QUESTIONS AND ANSWERS

IFB 01252024JKG Bolton HS Roofing Repair

Bolton High School

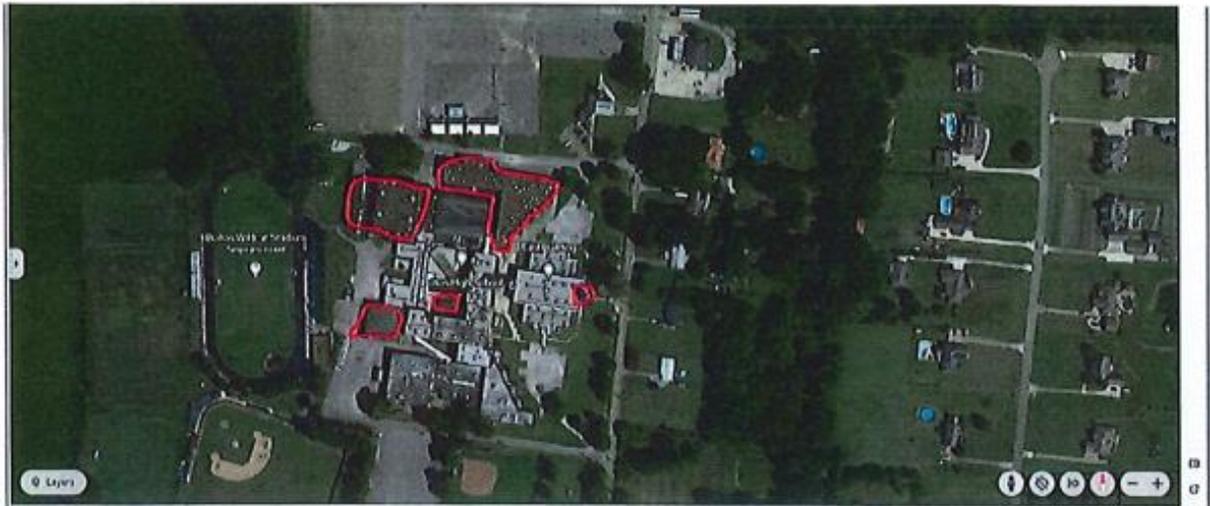
10. Scope of work (Part IV page 13 of IFB) states to “Patch and Repair any areas that are leaking.” This statement needs to be clarified with either a written location of each area that is leaking (or a more preferred method) a map that illustrates locations based on either a floor plan of the area or an aerial view of the roof(s) with

each area marked and highlighted. For example: there may be 1 area leaking or there may be 20 areas. The fixed pricing that is being requested on the bid form cannot be given when there is a variable scope of work.

11. Scope of work (part IV page 13 of IFB) states “Inspect entire roof over Main Office, Café, N Building and Gym area for visible damage.”

- a. The areas that will require work need to be defined via a drawing or aerial photo. Several of the projects have adjoining roofs that connect to what we assume is the cafeteria area. We request a better illustration of the work area that is mentioned in the IFB.

Please refer to the image on the last page.

Please refer to the image on the last page.

Main office area- repair penetration, a/c curbs, field sheet seams, and scuppers.

Café area (shingles)

N Building
